Camden Residents' Action Group

**Re: Land & Environment Court (Proceedings No. 81653 of 2020)
Camden Council ats Graham & Sanders
Consent orders hearing 18 June 2021.**

We strongly object to the proposed development at 20 Elizabeth Street Camden, which is located in Camden's Heritage Conservation Area (HCA) and adjacent to and in the near vicinity of a number of heritage- listed items. In particular, the iteration of the proposal that is presented to the Court is essentially similar to those that have been previously refused or failed in conciliation due to failure of justification for height exceedance and because of detrimental heritage impacts. This iteration also does not satisfy many of the contentions raised in Camden Council's Statement of Facts and Contentions (SOFAC).

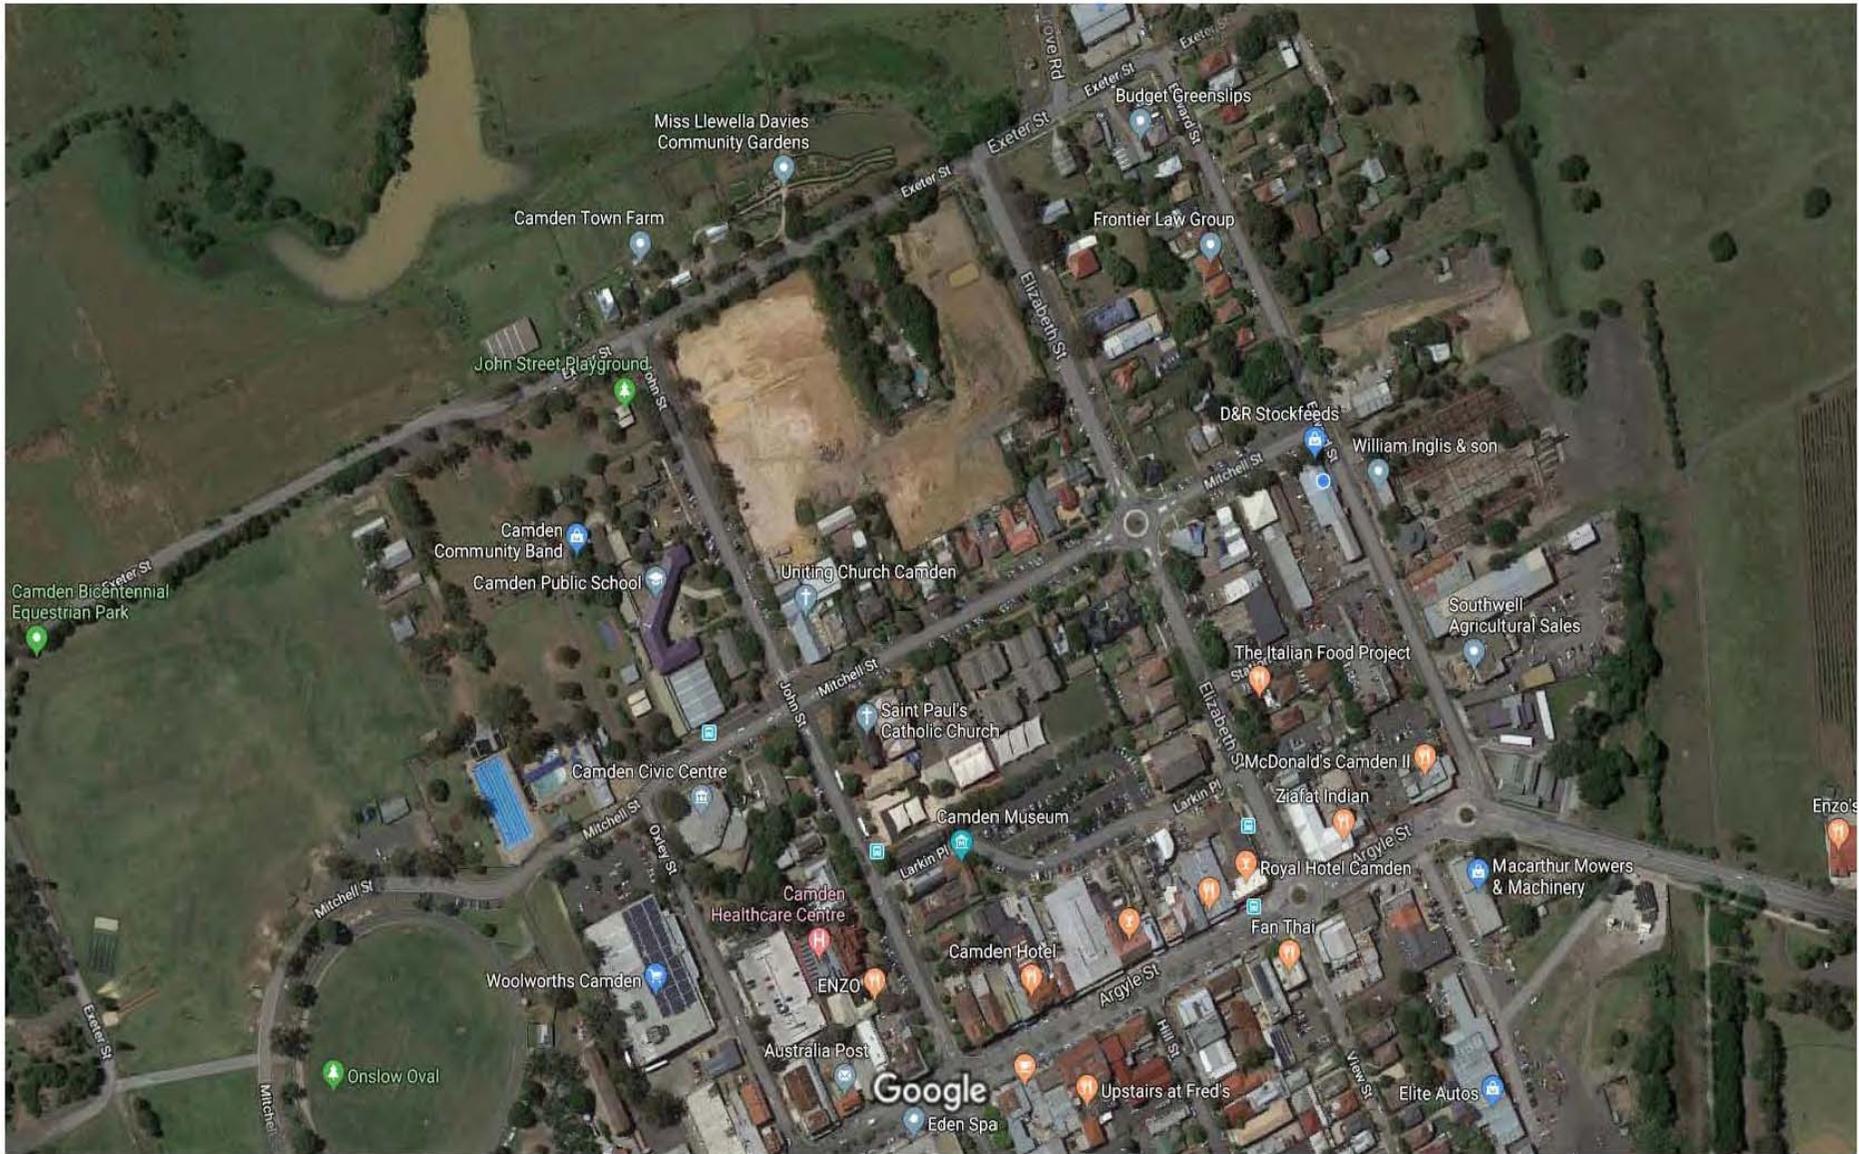
The Clause 4.6 Request (pp. 8,9) claims that development not only responds to the character of both the subject urban block, as well as the Elizabeth Street streetscape, it also provides abundant landscaping sympathetic to the adjoining heritage items fronting Mitchell Street and ensuring that the proposal appears as recessive. It also claims that the proposal provides a quantity of new plantings that is well in excess of that commonly provided to surrounding properties.

As can be seen in the aerial view above this is clearly an overstatement and not consistent with the historic pattern of surrounding development or the town's rural heritage and renowned leafiness.

The proposed plantings, with little room and shaded by the building itself are unlikely to grow, particularly on the southern side.

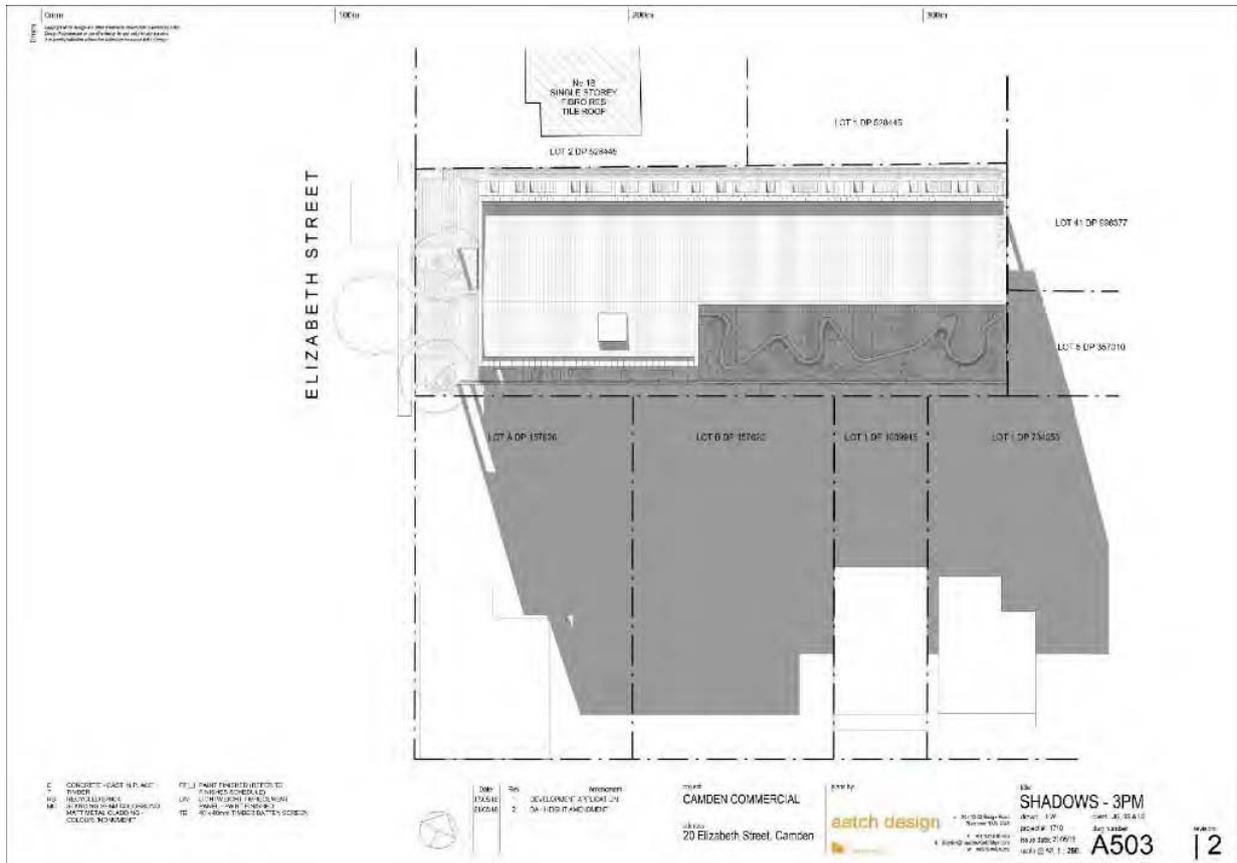
Compared to the adjacent tallest outbuilding (5.9 metres) of Nepean House, as shown in the indicative graphical representation below, the proposed building is of massive scale and almost twice as high.

The proposed building is more than twice as high as most other nearby properties. Nepean House itself is only 8 metres high including architectural roof features.

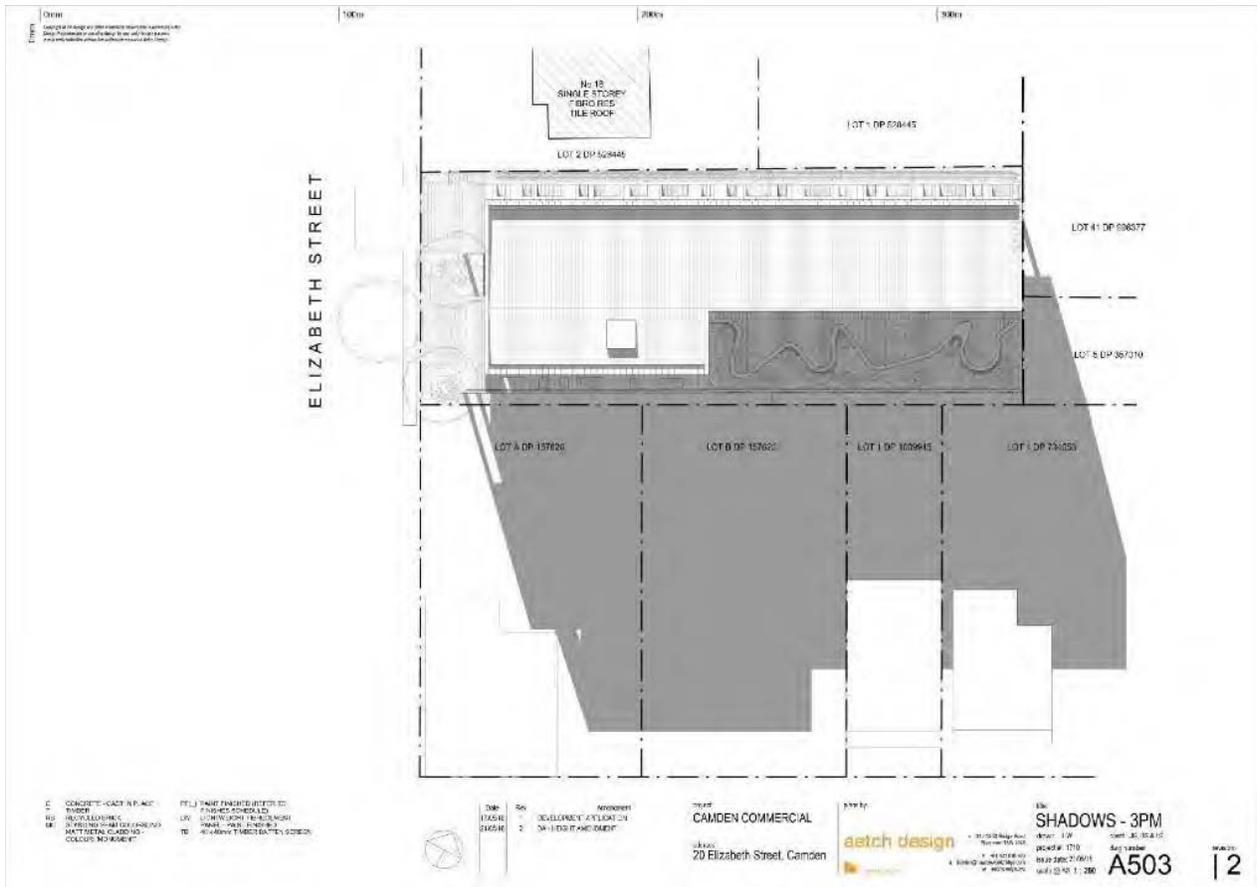
As a very telling comparison the heritage listed cottages, adjacent at 1 and 3 Mitchell Street, are around 3m in height to their rooftops, which are architectural features. The cottages are miniscule in relation to the proposed building. Note the proposed building would also be closely adjacent to the outbuilding at 50 a part of which is captured to the left in the above graphic.

Most properties in the vicinity would experience a building that is more than twice their height and many would be confronted by a first store landscaped rooftop 11m above ground level at the rear of the building and/or another two levels of second and third store office windows on both the south and north elevations.

The height differential of roughly 11 and 12 metres between the proposed building and its potential neighbours is preposterous.
